**BEFORE THE WASHINGTON
UTILITIES AND TRANSPORTATION COMMISSION**

**In the Matter of Puget Sound Energy's
Draft 2021 Electric Integrated Resource
Plan**

**In the Matter of Puget Sound Energy's
Draft 2021 Natural Gas Integrated Resource
Plan**

**COMMISSION STAFF COMMENTS REGARDING
PUGET SOUND ENERGY'S DRAFT INTEGRATED RESOURCE PLANS
SUBMITTED IN COMPLIANCE WITH
RCWs 19.405, 19.280 and WACs 480-90-238, 480-100-600 through-630,
ORDER 02 UNDER DOCKETS UE-180607 and UG-180608,
AND UNDER CONSOLIDATED DOCKETS UE-191023 AND UE-190698, Order R-601**

Figure 1-1: Electric Peak Hour Capacity Resource Need after Cost-effective Demand-side Resources ⁸

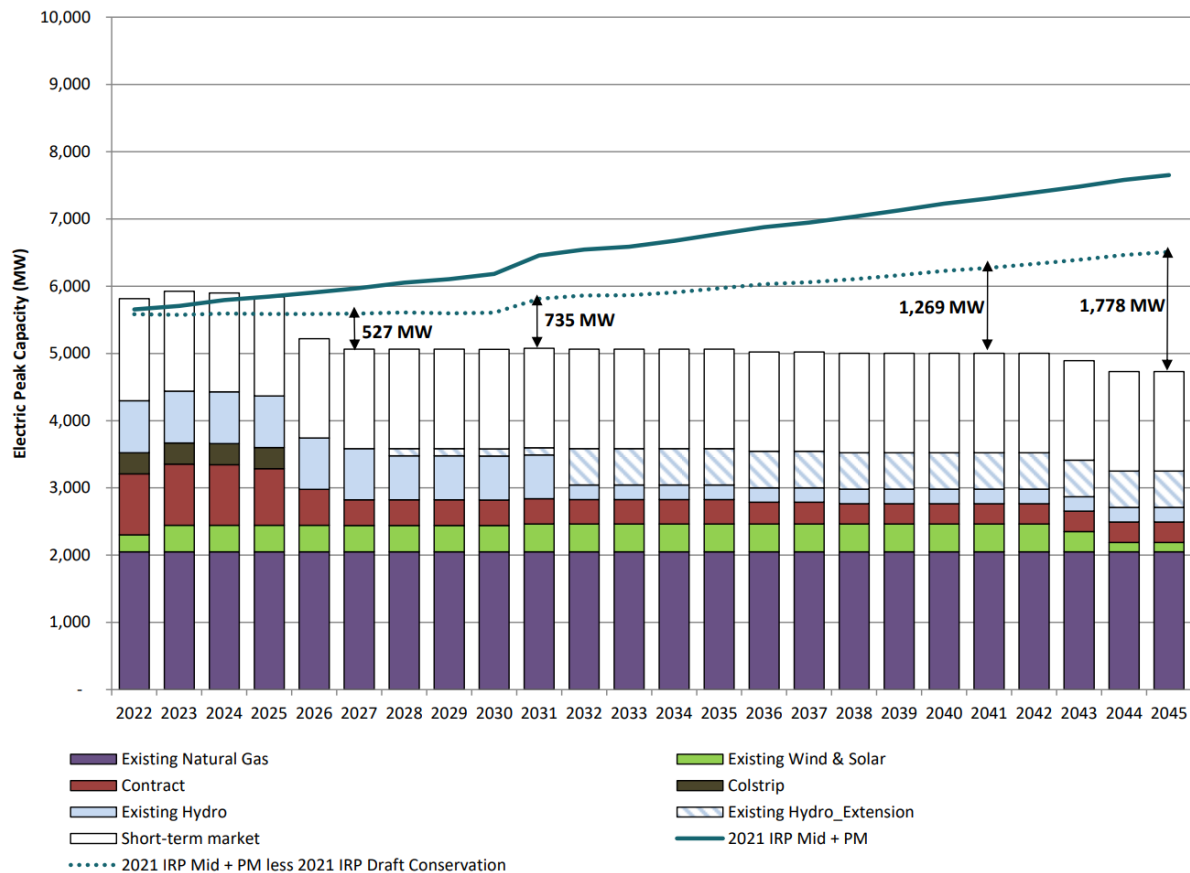
Capacity: During the 2019 IRP process, PSE forecasted a capacity shortage in the first year of the planning horizon, with a 685 megawatt (MW) resource deficiency in 2022.⁶ The company’s Draft IRP tells a different story. As shown in Figure 1-1, PSE now projects sufficient capacity through 2025, assuming cost-effective conservation and demand response is acquired as forecast,⁷ and if approximately 1,500 MW of short-term market resources are available. Staff notes in addition to availability, financial risk is also a tangible consideration as PSE’s market reliance position extends to upwards of 25% of its resource portfolio.

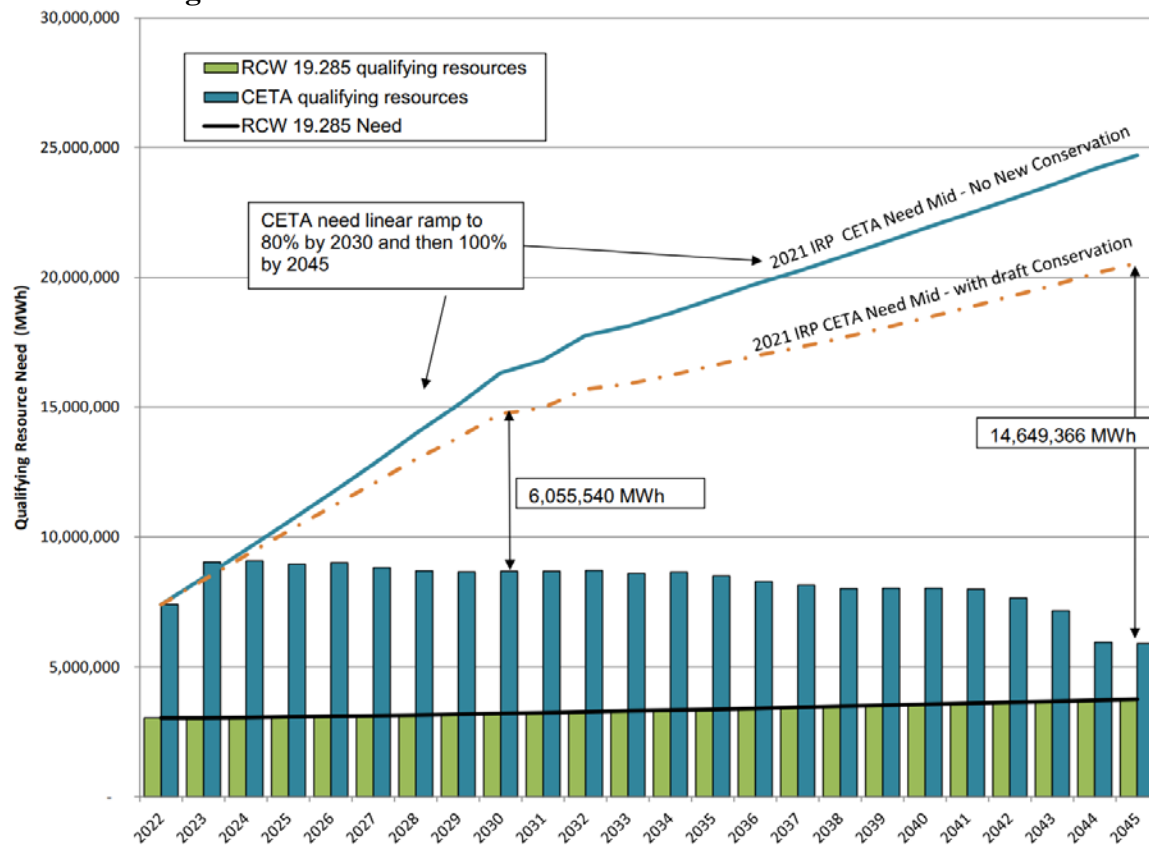
Energy: Comparing PSE’s forecasted annualized energy needs tells a similar story, with a noticeable reduction in average megawatts (aMW) in the more recent Draft IRP forecast. In the 2019 IRP process, PSE forecasted roughly 2700 aMW of annualized energy need in 2022, increasing to almost 3500 aMW by 2039.⁹ In the Draft IRP, the company forecasts just over 2500 aMW of system need in 2022, escalating to roughly 3300 aMW by 2045.¹⁰
